Re: Water Use License 1BR-DYE0409

UMA Engineering Ltd. is submitting the following proposed modifications as per Section H.1 of the existing license. The notification of modifications is being submitted on behalf of Defence Construction Canada and the Department of National Defence.

The following modifications are being proposed as part of the clean up of the DYE-M, Cape Dyer DEW Line site.

FRONT ELEVATION

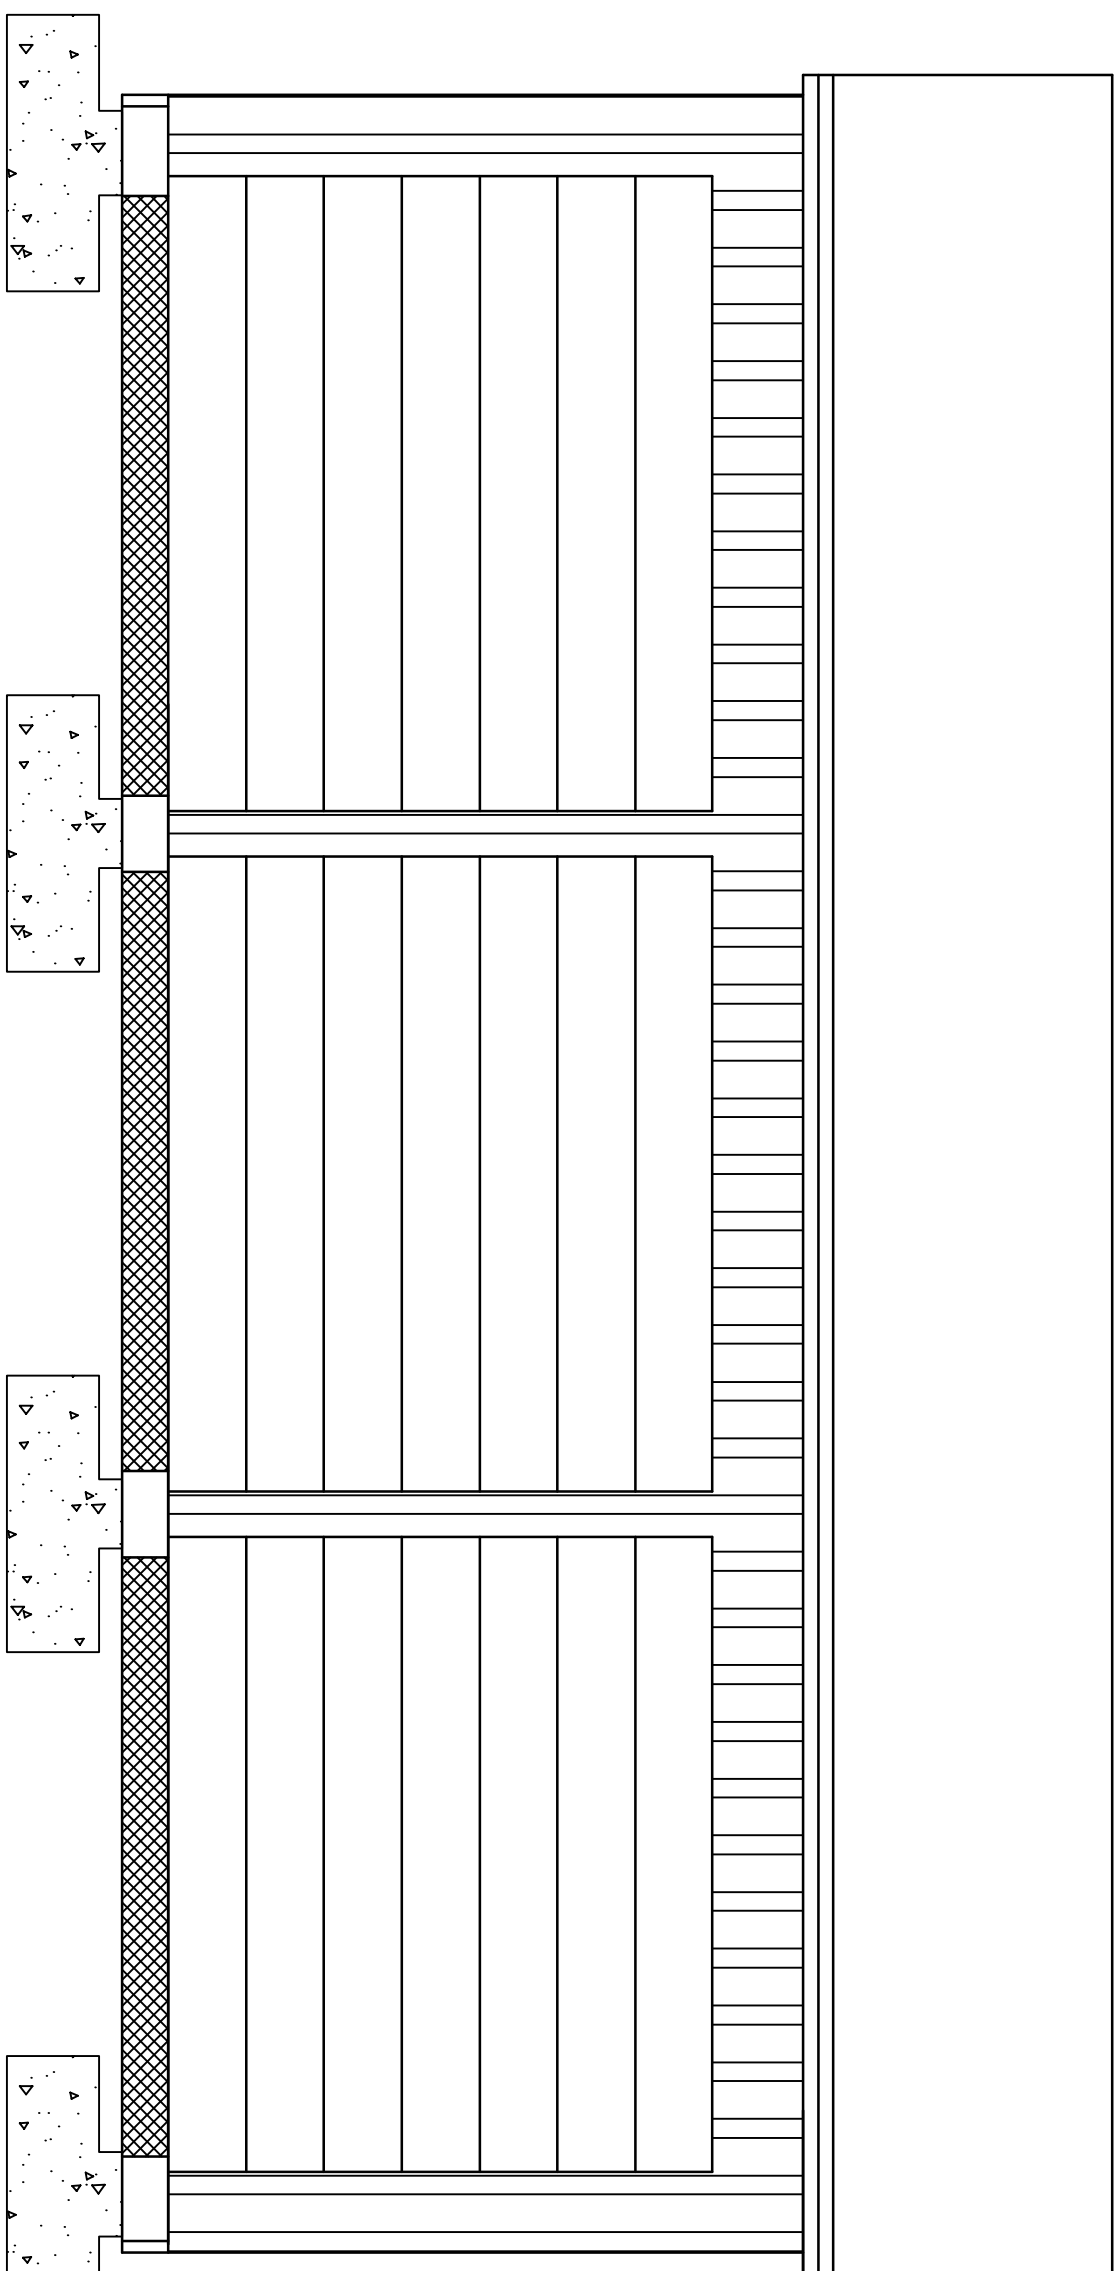
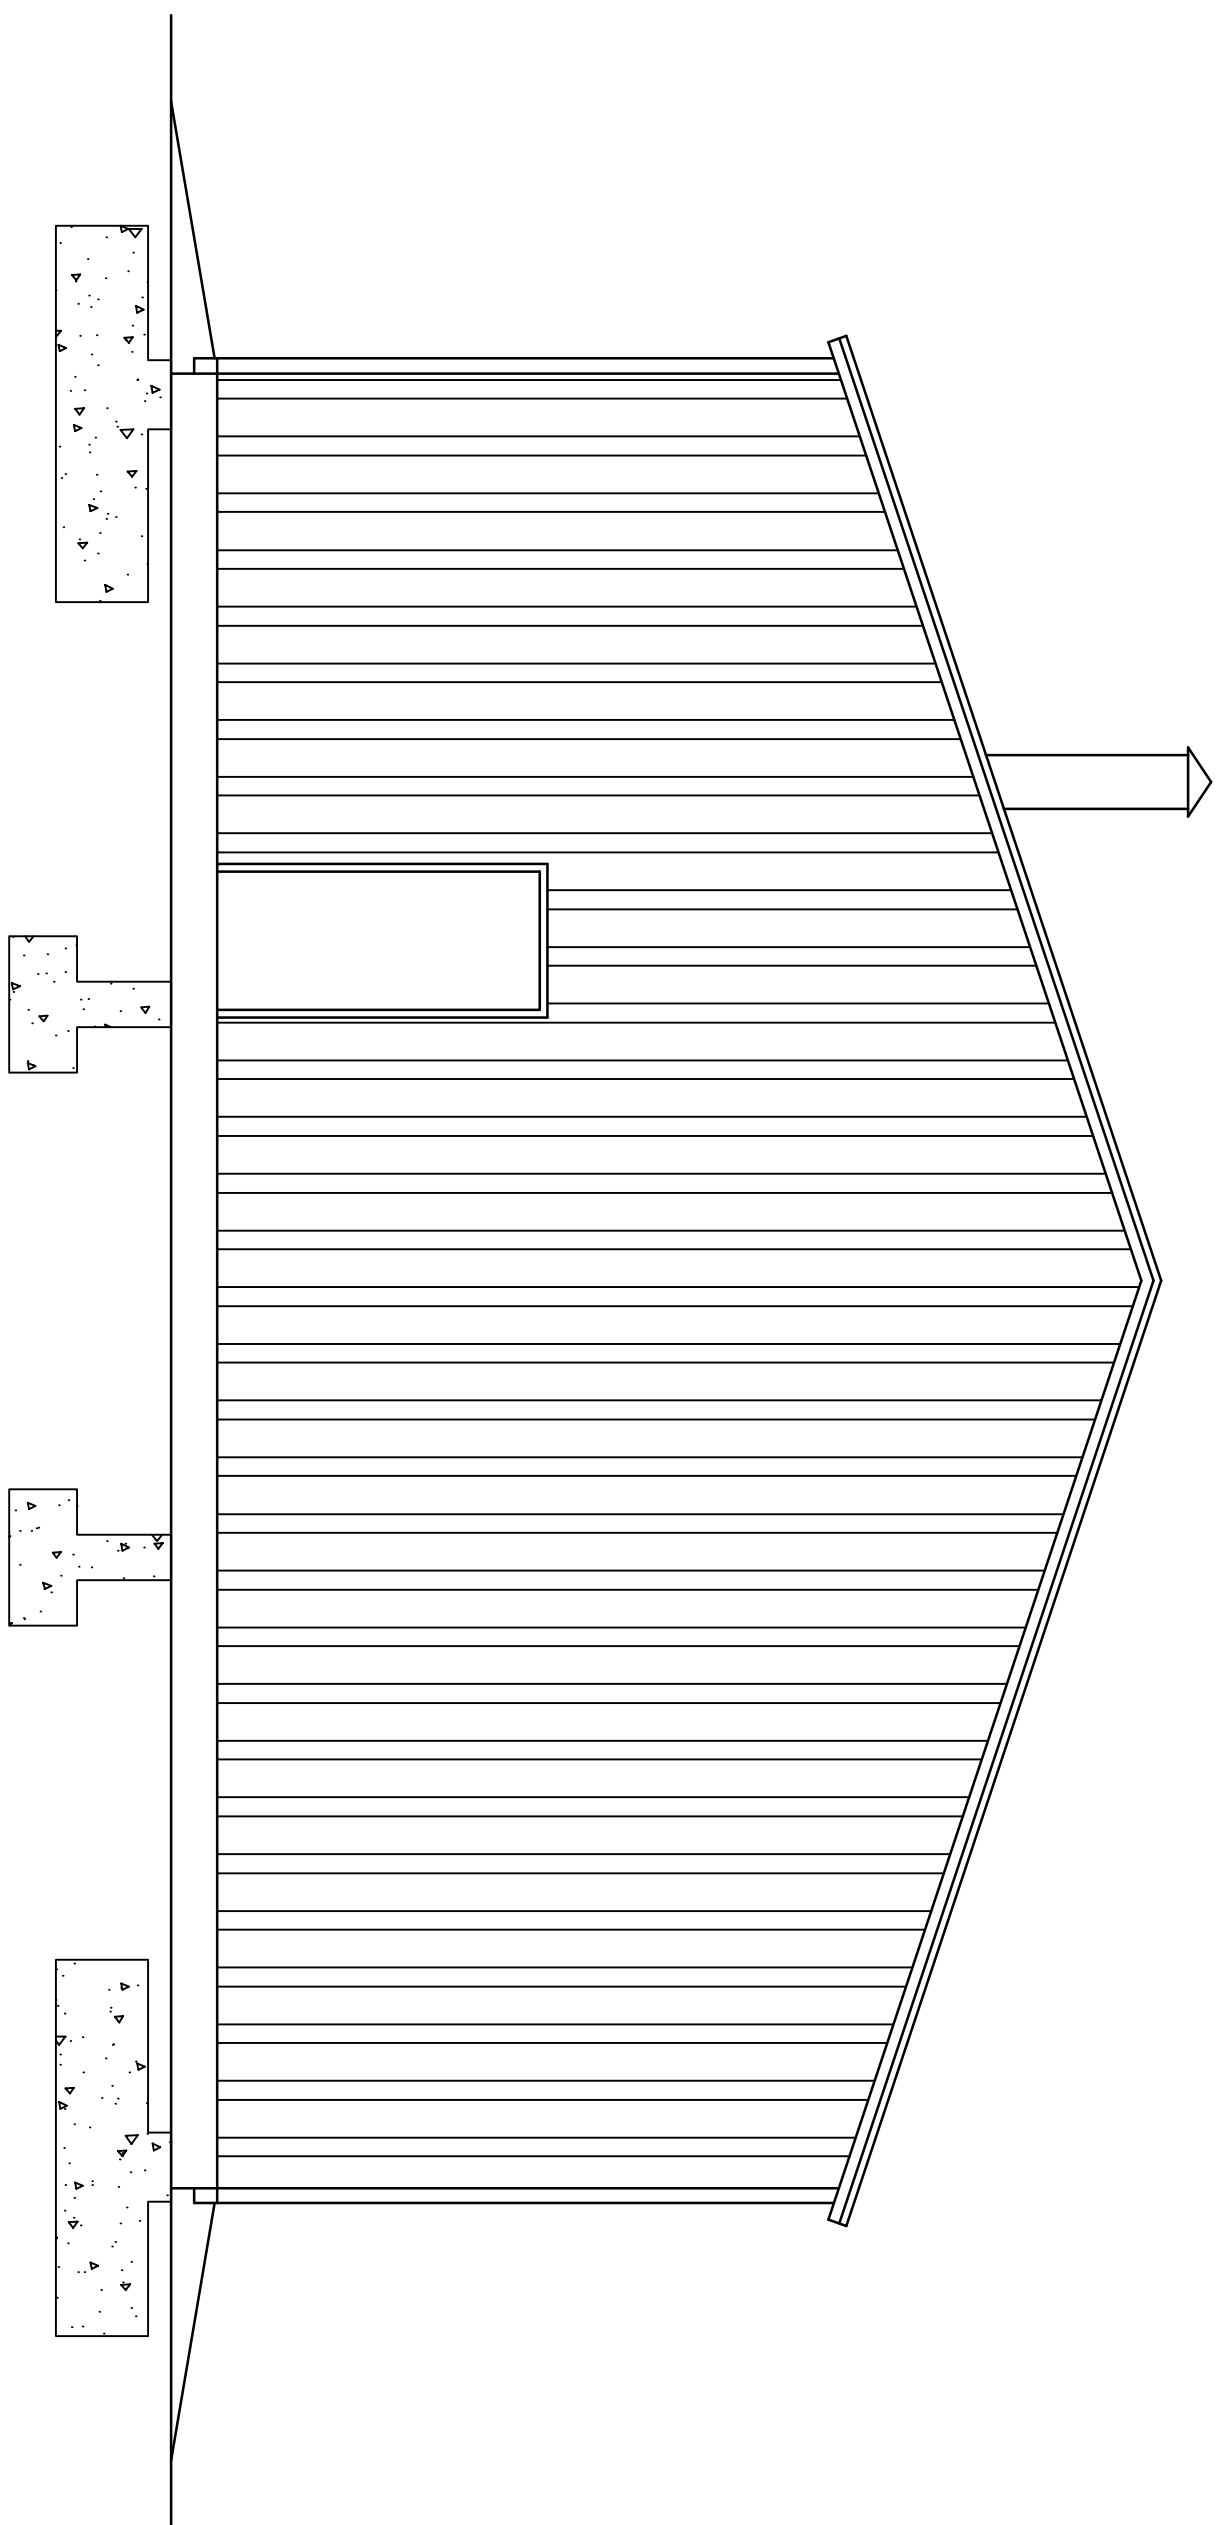
- 2.) Nine additional buildings at the Lower Site are to be demolished, including the air terminal building, four warehouses, two atwell dormitories, the heated vehicle storage building and the garage. However, the demolition of module train C and the walkway from module train B to module train C identified for demolition in the original submission will be cancelled and the buildings will remain.
